Access Compliance Report

Public Rights-of-Way (Curb Ramps)

Intersection ID: 21469	Main Street: HOLLY_LN	Cross Street: NEWMANS_LN	Location: NE
ADA ID: 5DFE08EB520B	Ramp Type: PerpDiag	Initial Pass/Fail: Fail	Overall Compliance: No
		Severity Score: 46.25

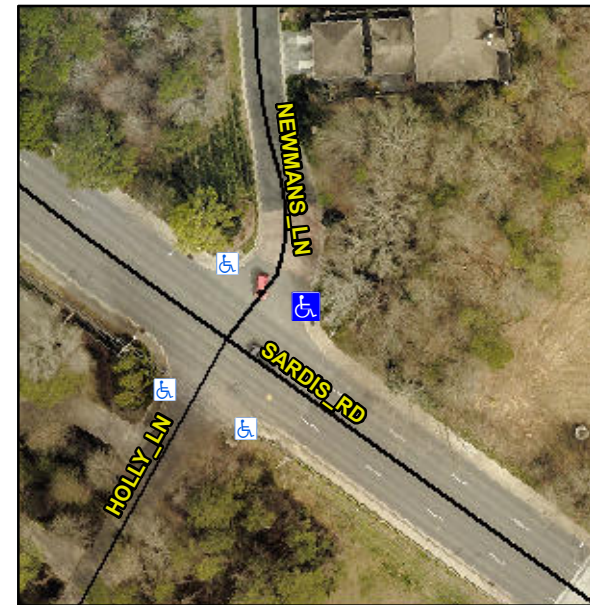
Not Found, R304.5.1, R304.2.2, R304.5.3

Compliance	Description	Data	Compliance	Description	Data
N/A	Ramp Length (in)	61.0	No	Ramp Slope (%)	11.8
No	Ramp Width (in)	44.0	No	Ramp XSlope (%)	9.5
N/A	Flare Type LT	N/A	N/A	Flare Type RT	N/A
N/A	Flare Slope LT (%)	N/A	N/A	Flare Slope RT (%)	N/A
N/A	Flare Traversable LT?	N/A	N/A	Flare Traversable RT?	N/A
N/A	Landing Length (in)	N/A	N/A	DWS Provided?	N/A
N/A	Landing Width (in)	N/A	N/A	DWS Contrast?	N/A
N/A	Landing Slope (%)	N/A	N/A	DWS Length (in)	N/A
N/A	Landing X Slope (%)	N/A	N/A	DWS Full Width?	N/A
N/A	Landing Curb? (Y/N)	N/A	N/A	DWS Offset (in)	N/A
N/A	Shared Landing?	N/A			
N/A	Gutter Ponding?	N/A	N/A	Gutter Slope (%)	N/A
N/A	Gutter Lip Ht (in)	N/A	N/A	Gutter X Slope (%)	N/A
N/A	Painted X Walk1?	No	N/A	Painted X Walk2?	No
	X Walk 1 Direction	To NW		X Walk 2 Direction	To SW
N/A	X Walk 1 Width (in)	N/A	N/A	X Walk 2 Width (in)	N/A
	X Walk 1 Slope (%)	0.7		X Walk 2 Slope (%)	9.5
	X Walk 1 X Slope (%)	4.7		X Walk 2 X Slope (%)	2.8

N/A	Ramp inside XWalk1?	N/A	N/A	Ramp inside XWalk2?	N/A
	Road Slope (%)	5.5	N/A	Clear Space?	N/A
	Road X Slope (%)	4.1	N/A	Clear Space to XWalk (in)	N/A
N/A	Any Obstructions?	N/A	N/A	Storm Grate/Utility Hazard?	N/A
	Obstruction Type			Storm Grate/Utility Type	
		N/A			N/A
			Yes	Surface Condition? (G/P)	Good

Remove & Replace Curb Ramp With Two New Directional Ramps or Equivalent.
